Access Compliance Report Public Rights-of-Way (Curb Ramps)

Intersection ID: N/A Main Street: CAMPBELL DR Cross Street: DRIFTWOOD DR SE Location: **Overall Compliance: No Severity Score:** 0 ADA ID: D048DC13F72A Ramp Type: Combination1Diag Initial Pass/Fail: Fail

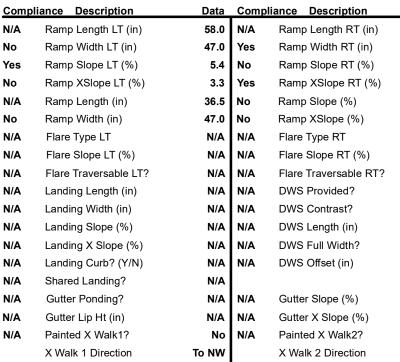
StopSign **CAMPBELL DR** None DRIFTWOOD DR Possible Solutions: Remove & Replace Curb Ramp With Two New Directional Ramps or Equivalent. Surveyor Notes: N/A PROW/ADA: R304.5.1, R304.5.1, R304.2.2, R304.5.3, R304.3.2
